Client: Guy C Lee - Clayton
Project: 201811-5003 Kensington Park
Address: 460 Carolina Way, Sanford, NC 27332

FIELD DAMAGE REPORT

Name: Kensington Park- 201811-5003- J4 / NC Date: 1/16/2019
Address: 460 Carolina Way, Sanford, NC
Contact Phone: 919-553-6699 Contact Name: Shawn Norris
Contact Company: Guy C Lee Clayton

J4 EEI™ 30 Joist 11.875" - PASSED

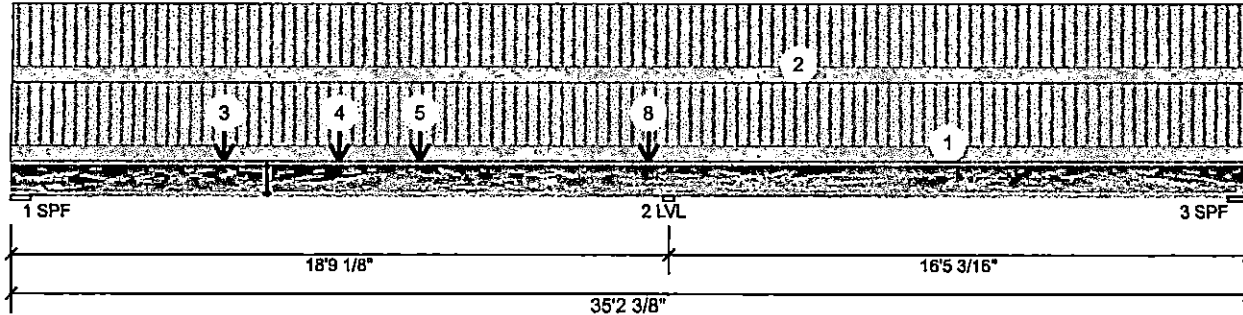
Attached is a jost that had had a notch made in the top flange. Located 7' 4" from the left end, the notch goes into the flange 1/2", and is 3" long. Need repair if necessary, and NC seal.

NO REPAIR REQUIRED – Member OK as is

NO REPAIR REQUIRED – Member OK as is
